Addendum D1

re: **SB849 – Schurz Library – 4th & 5th Floor Restroom Remodel**
Indiana University South Bend
 IU Project #20240679

issue date: **April 1, 2026**

5 Fourth Floor Restroom Plan - Base Bid
1/4" = 1'-0"

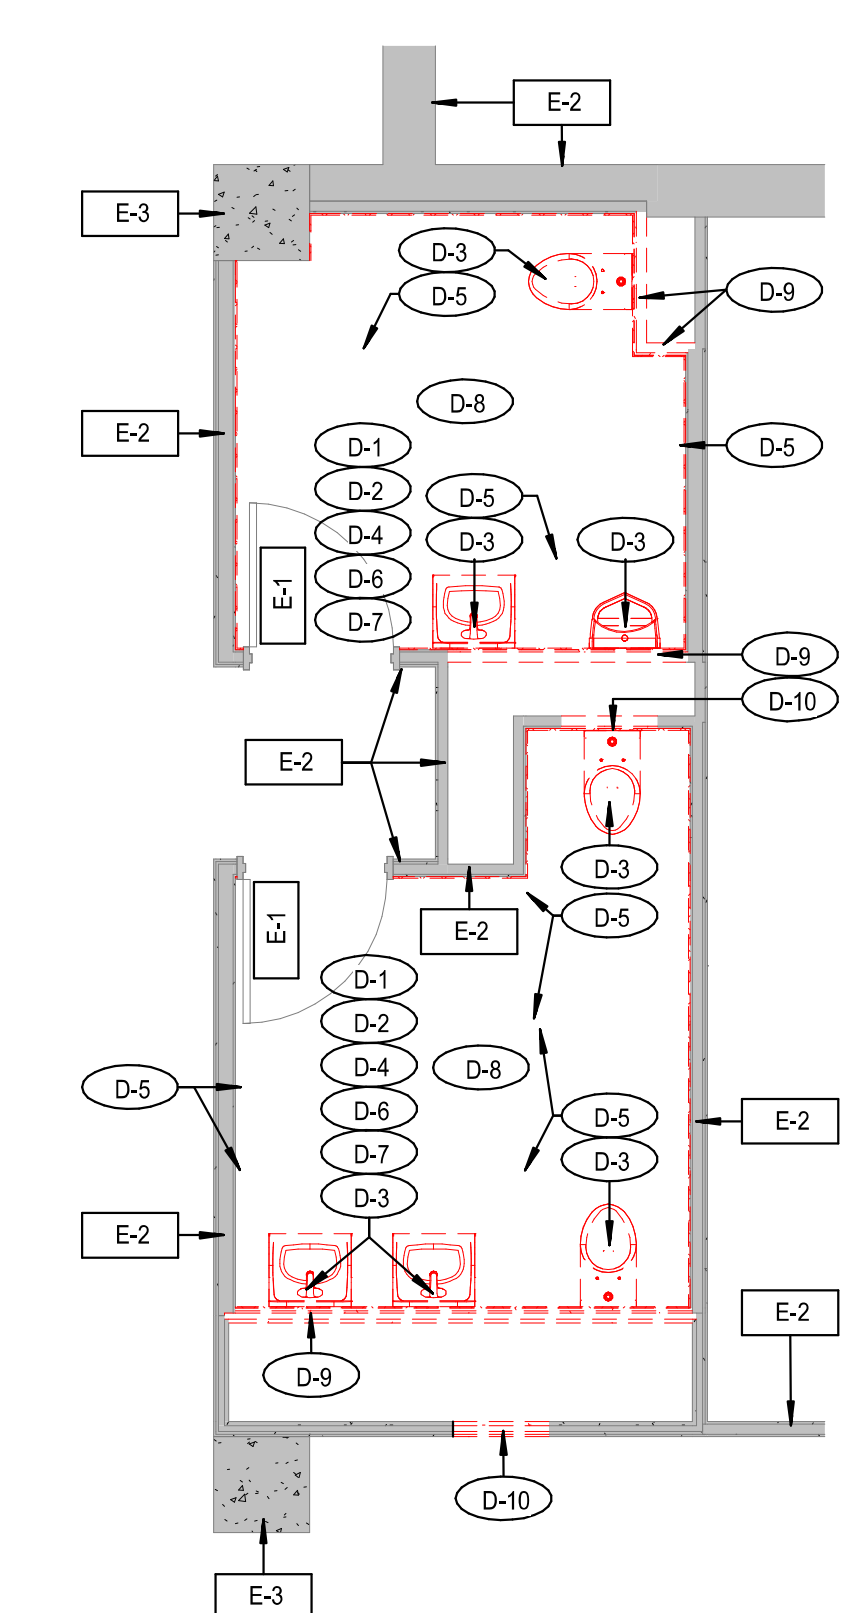
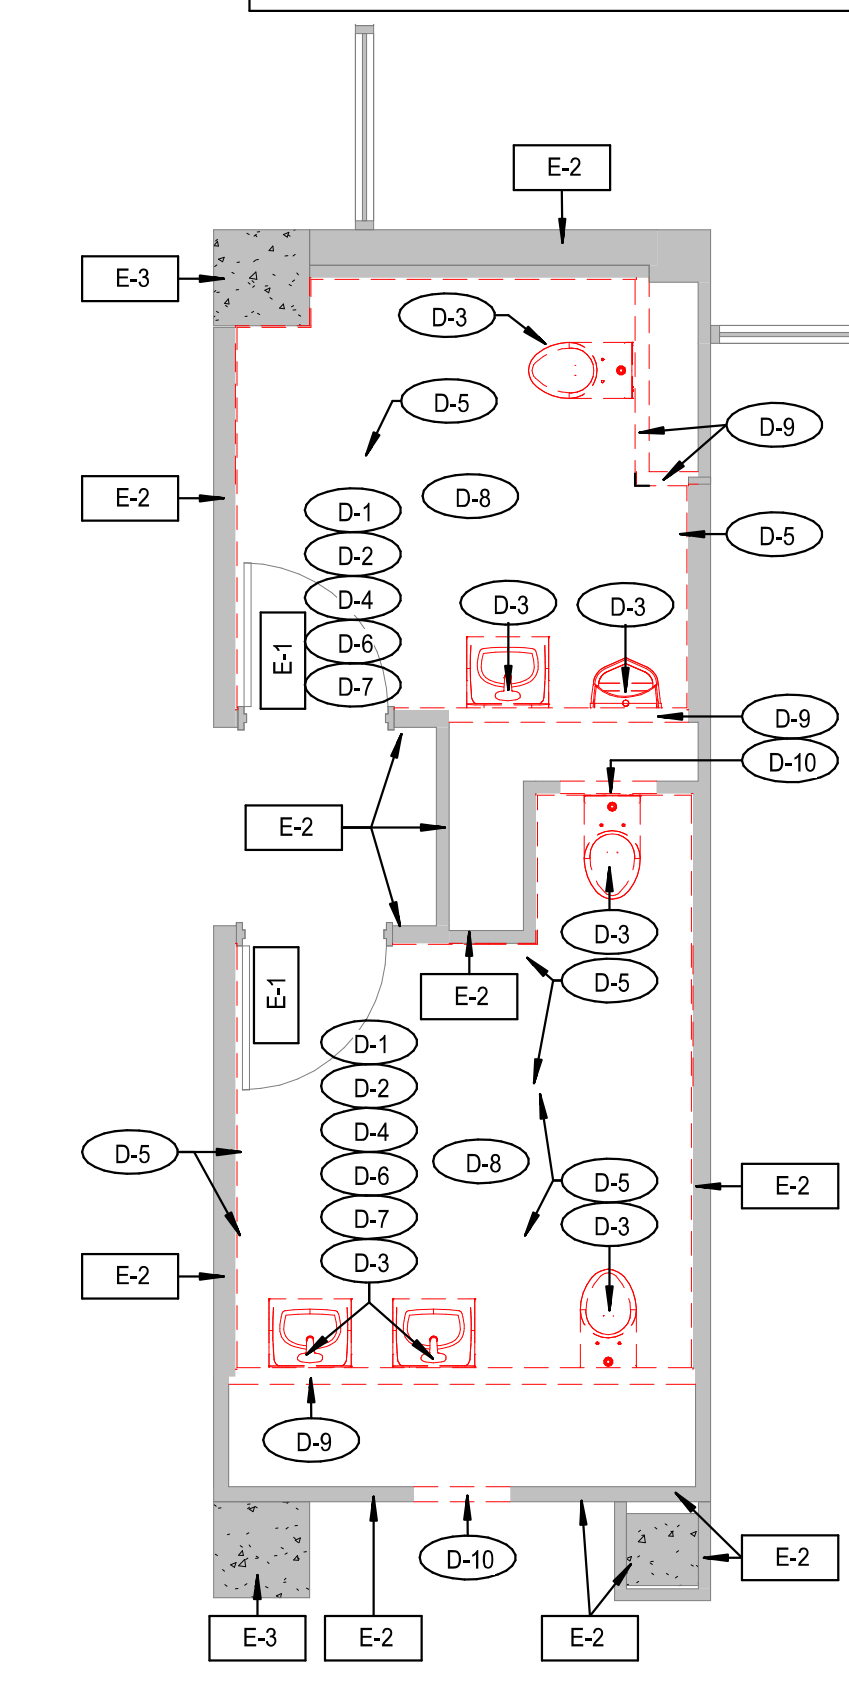
A1.07	DRAWINGS A2.1 (Drawing Reissued)	<u>ADD:</u> Sheet A2.1 reissued to include coat hook tags on the fourth floor; ADA signage on the fourth and fifth floor; and updates to the accessory schedule to indicate access panel sizes and paintable access doors.

13 Typ. Restroom Counter Section
1" = 1'-0"

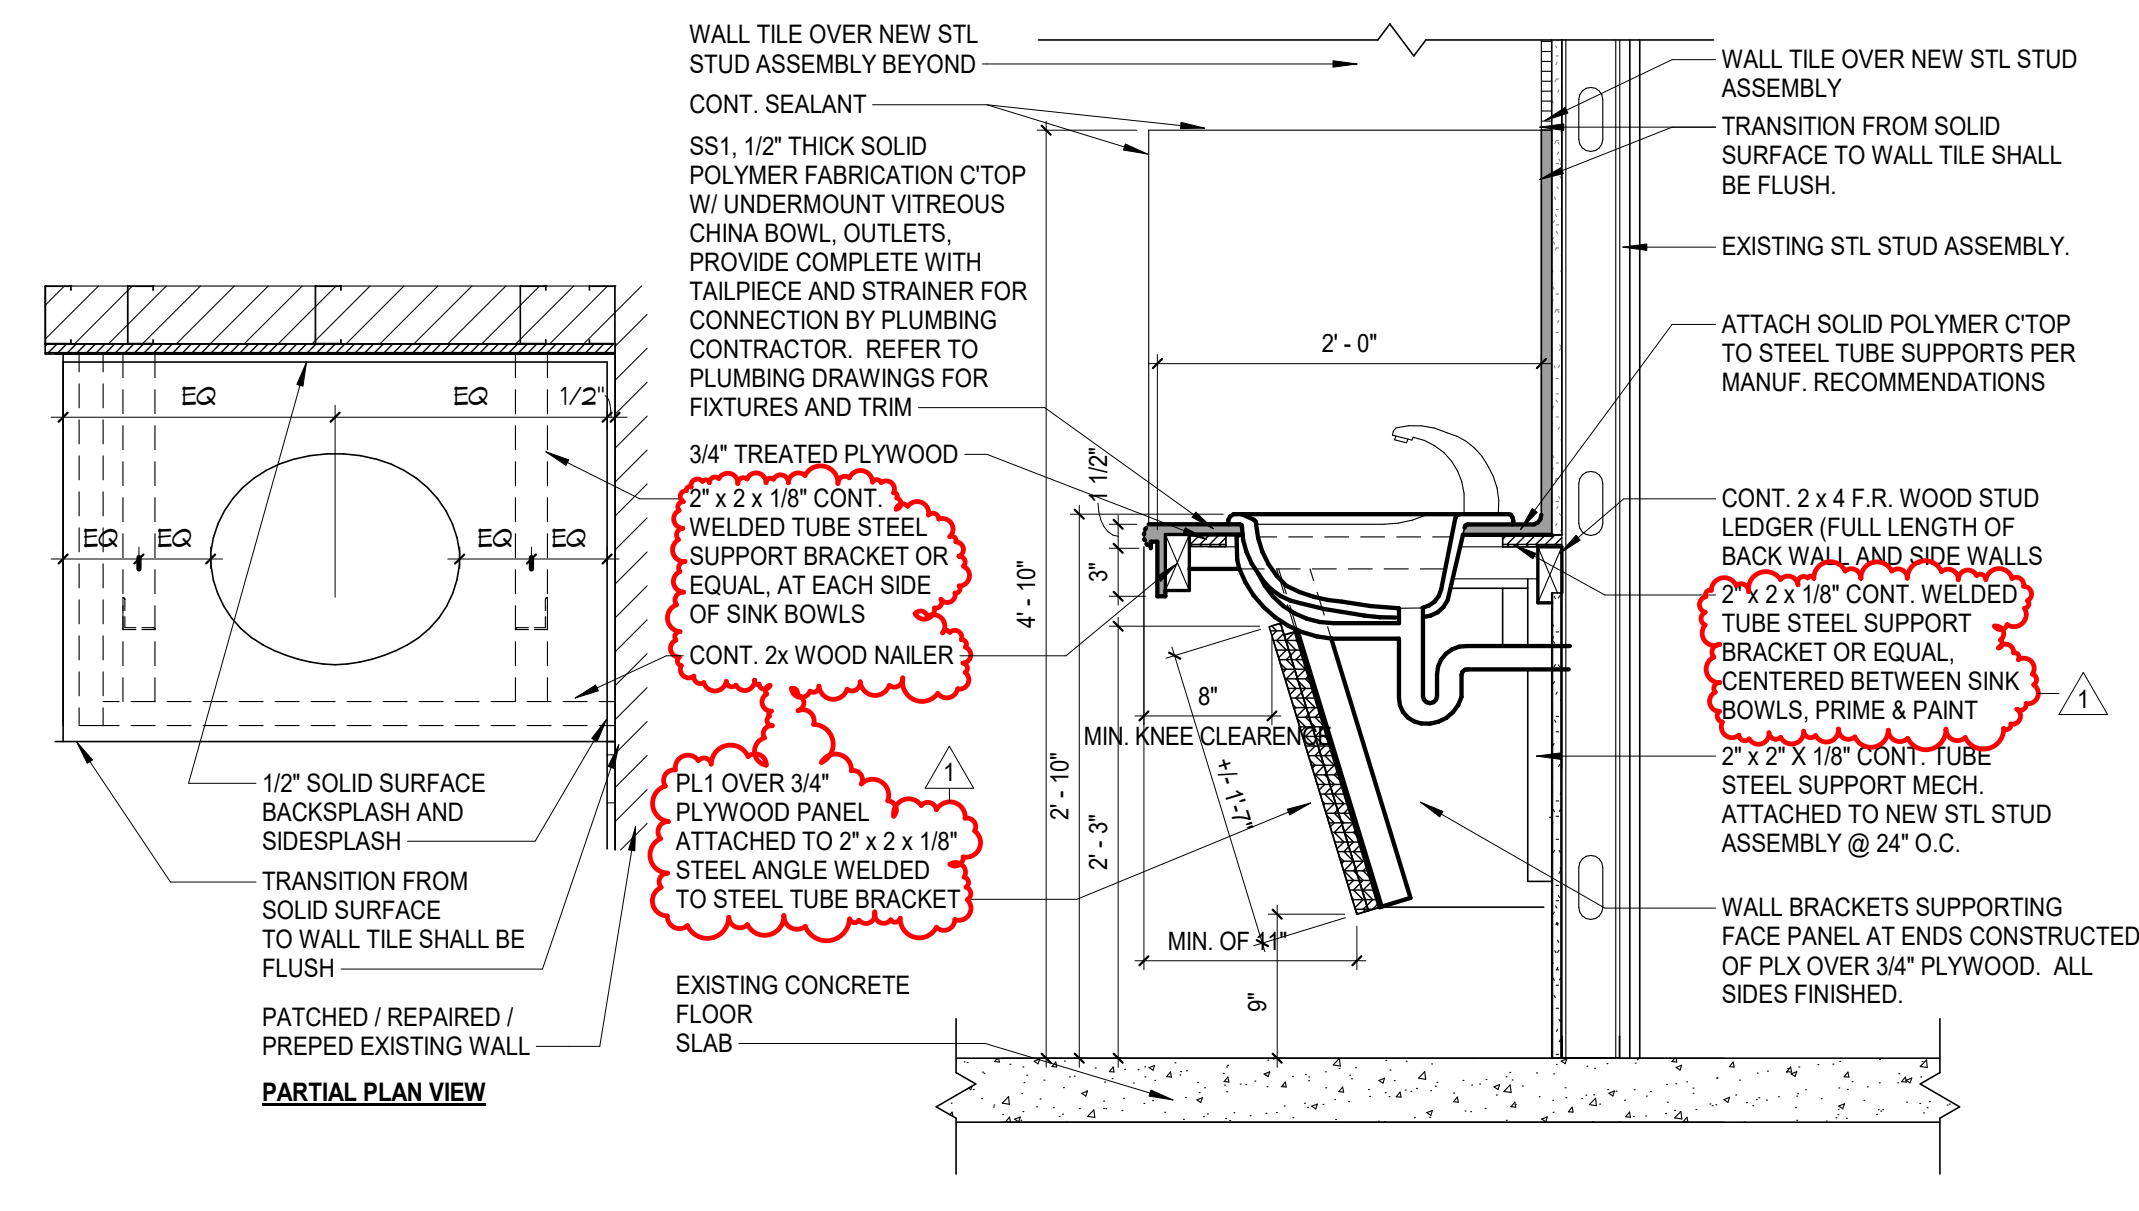
A1.08	DRAWINGS A3.1 (Drawing Reissued)	<u>ADD:</u> Sheet A3.1 reissued to clarify restroom counter support mounting in Detail 13.
-------	---	--
